NPP Lithuania

Expert Statement to the EIA Report

Ordered by the
Federal Ministry for Agriculture, Forestry,
Environment and Watermanagement,
Projectmanagement Department V/6 "Nuclear Coordination"
GZ BMLFUW-UW.1.1.2/0013-V/6/2008

REPORT
REP-0186

Figure 1: Core damage frequency as reported in the EIA Report compared to other sources.

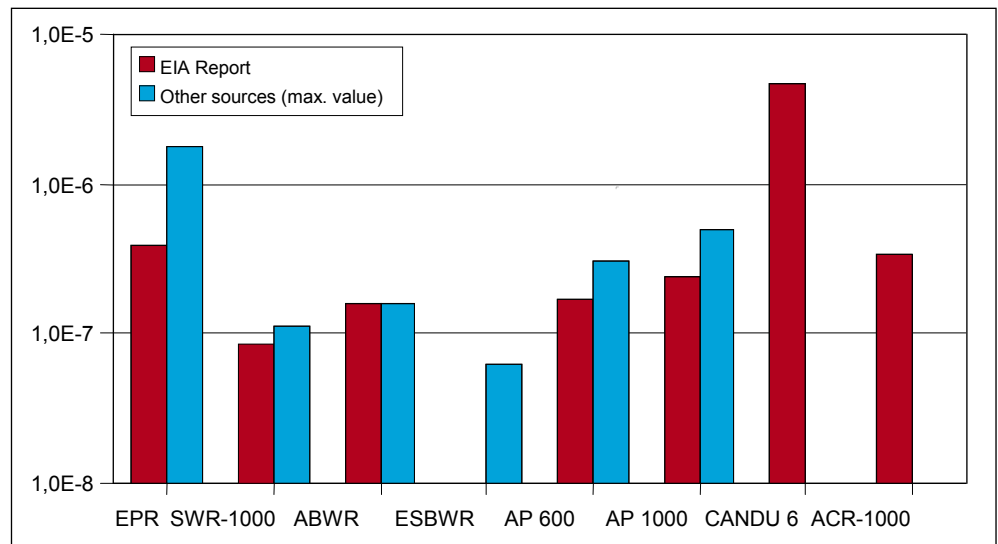
An evaluation and comparison of the numbers as provided in the EIA Report leads to the observations that CDF varies widely among reactor types – by a factor of almost 200. However, the relevance of the different CDF values for the assessment of different reactor types is not discussed in the EIA Report.

The synopsis of PSA results with their high variations and uncertainties (and possibly, inconsistencies) shows that it is not appropriate to rely too strongly on probabilistic criteria. The main criteria for the assessment of the reactor types should be deterministic.

A detailed presentation of the PSA results of the candidate reactors would be of interest (including the contributions of different events and plant states), as well as a discussion of their limitations and the bandwidths of their uncertainty. With this background, the differences in the results as indicated above should be discussed and assessed.

Figure 3: Core damage frequency as reported in the EIA Report compared to other sources.

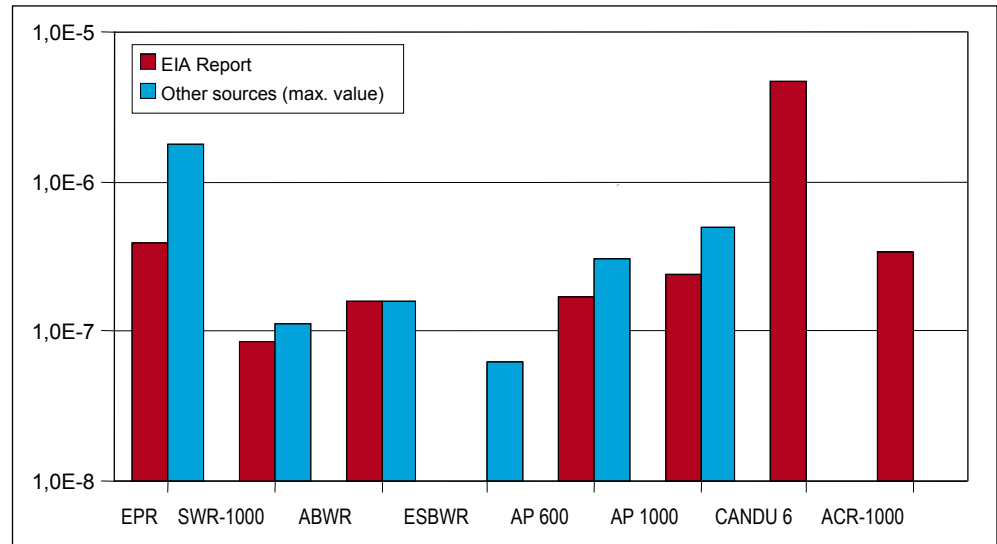
1. CDF varies widely among reactor types – the maximum value (APWR) is higher by a factor of almost 200 than the minimum value (V-448). (Even without the result for the APWR, CDFs span about two orders of magnitude.)
2. There is less variation in the reported LRFs (less than one order of magnitude).
3. The ratio between CDF and LRF varies considerably – from a factor of 6.5 (AP 1000) to factors of 460 (Enhanced CANDU 6) and 500 (V-392).
4. It is stated in the EIA Report that all candidate reactor plants meet the probabilistic requirements (CDF below 1.0E-5/yr, LRF below 1.0E-6/yr) “by a significant margin”. It appears, however, that the requirement for CDF is not fulfilled by APWR, V-392 and Enhanced CANDU-6. (Due to the uncertainties inherent in PSAs, a “significant margin” should be about one order of magnitude.)

The relevance of the different CDF values for the assessment of different reactor types and their candidate status is not discussed in the EIA Report; not even in cases where the CDF as reported in the EIA Report is close to the probabilistic requirement.

Furthermore, there is no discussion of the variations regarding the CDF/LRF ratio, and reason for the variations. Differences in the CDF/LRF ratio could indicate fundamental differences in reactor design, particularly regarding the control of core damage accidents. On the other hand, they could also be indicative of methodological inconsistencies and/or of high bandwidths of uncertainty in the level 2 PSAs of some reactor types.

Figure 4: Large release frequency as reported in the EIA Report compared to other sources.

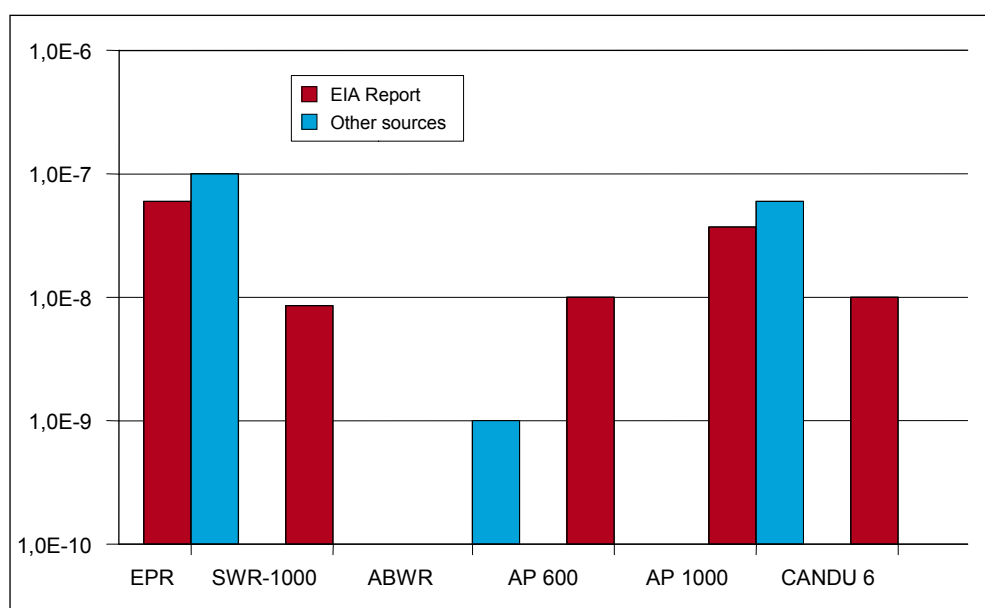
Altogether, the synopsis of PSA results with their high variations and uncertainties (and possibly, inconsistencies) shows that it is not appropriate to rely too strongly on probabilistic criteria. The main criteria for the assessment of the reactor types should be deterministic, with the results of probabilistic studies as a supplement only.
